Flat-cap garage · integrated photovoltaic roof

ELEVATIONS FIRST / Heights from garage ground datum / Concept dimensions, not construction details

REVISION FOR REVIEW

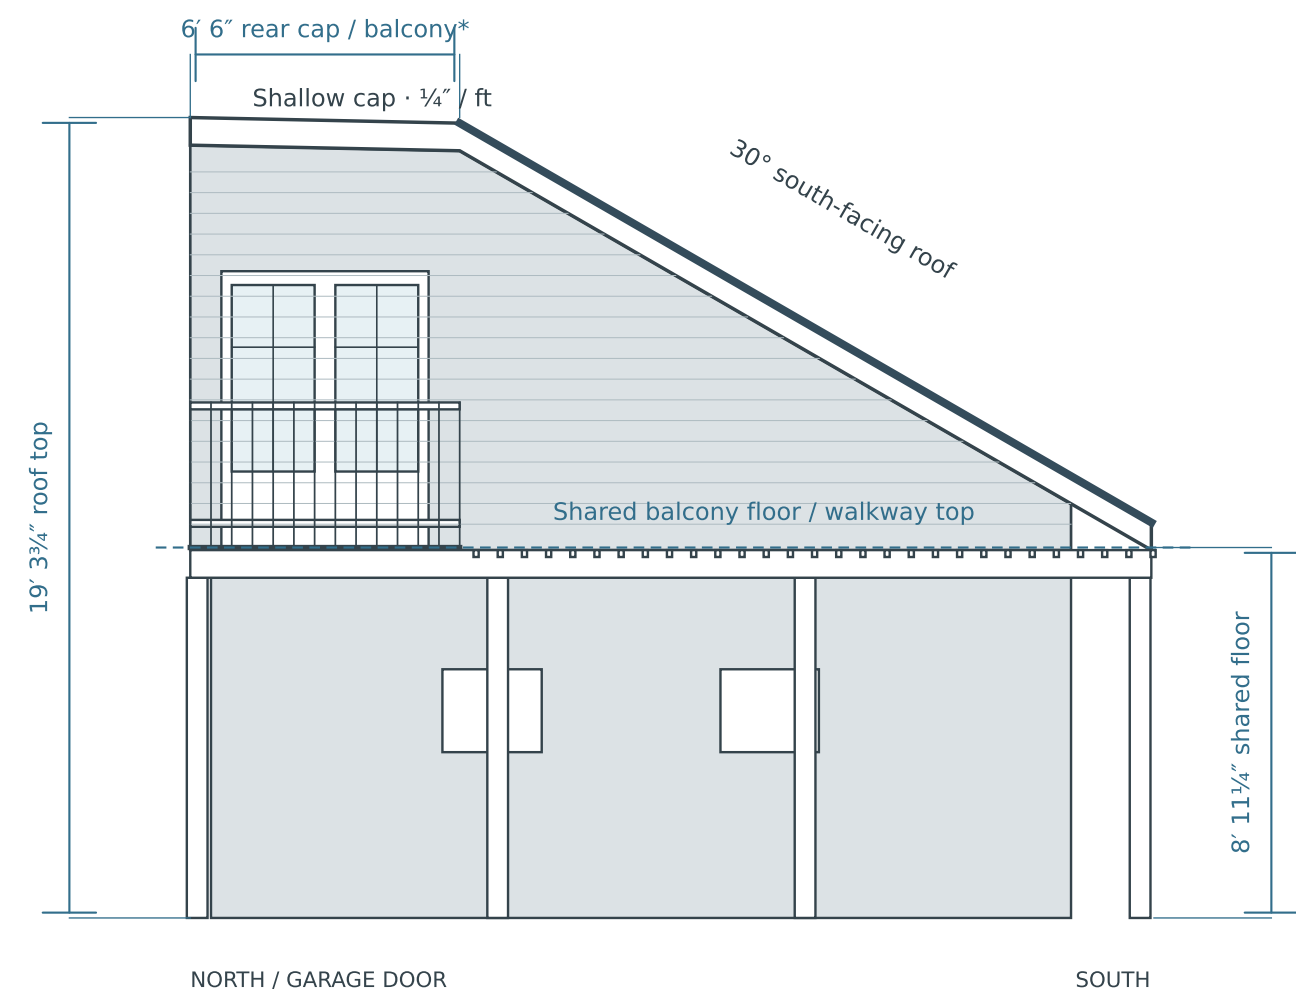
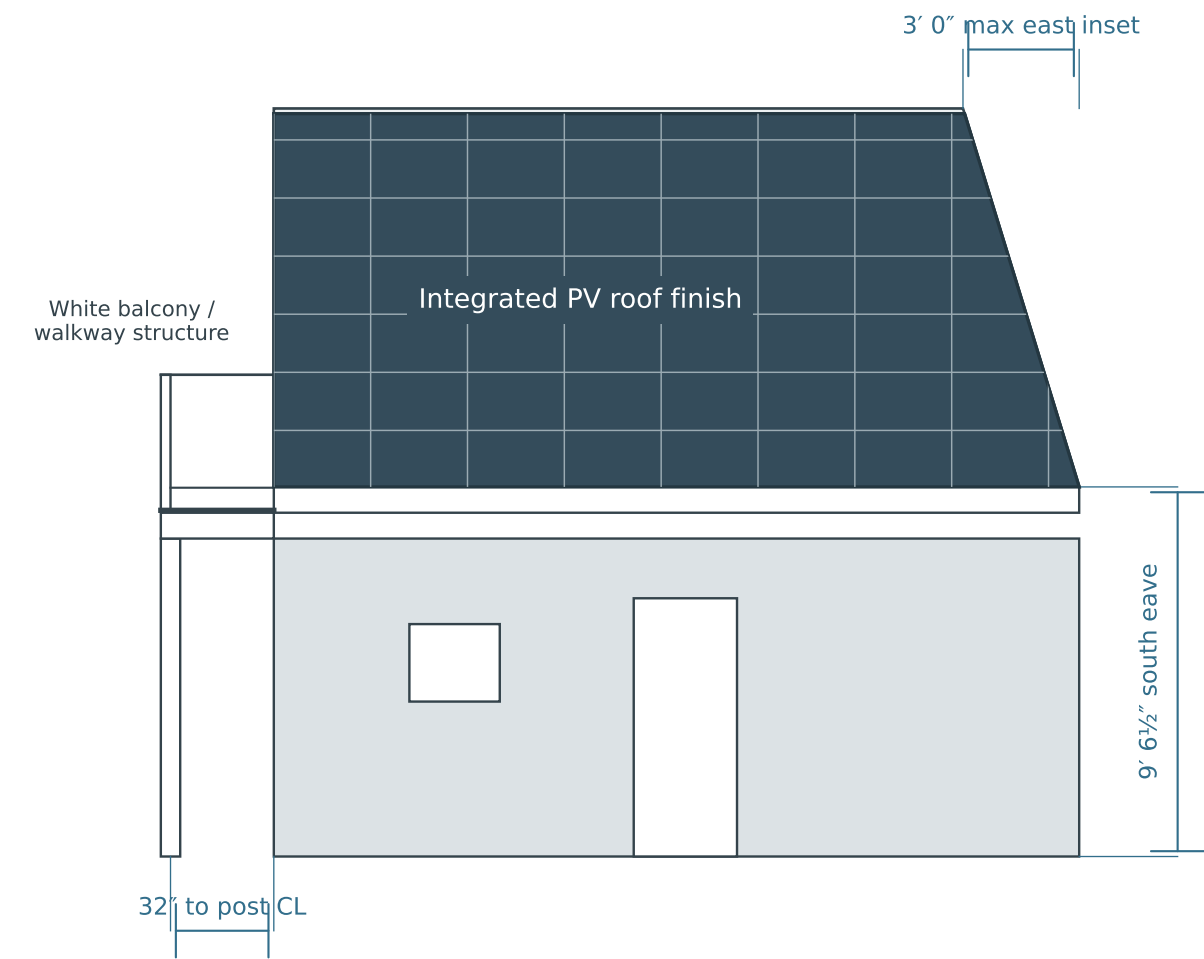
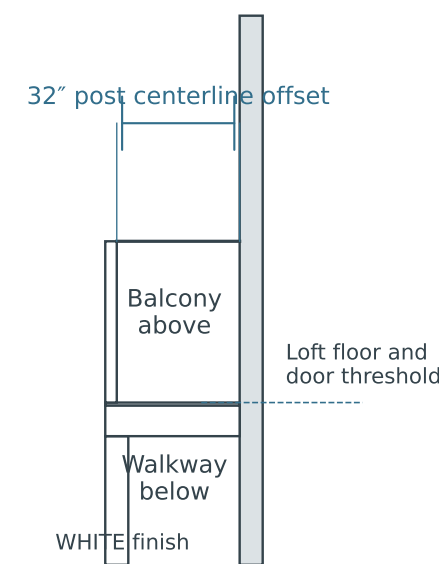
- Rear flat-cap option retained; full-slope option dropped.
- No lattice rises from the walkway to the main roof.
- One west beam/post row: 32 inches from the existing wall.
- Walkway roof and balcony floor share the loft floor level.
- Balcony, fascia, posts and beam shown white.
- Horizontal members over the remaining walkway; solid walking surface beneath the balcony and French doors.

* Provisional: balcony spans the 6 ft 6 in rear zone;
French doors 5 ft × 6 ft 8 in; railing 42 in high.
Existing assumptions retained: 8 in beam + 3/4 in deck.
Assembly thickness, drainage and connections need design.
No new east/south covered passage inferred in this sheet.
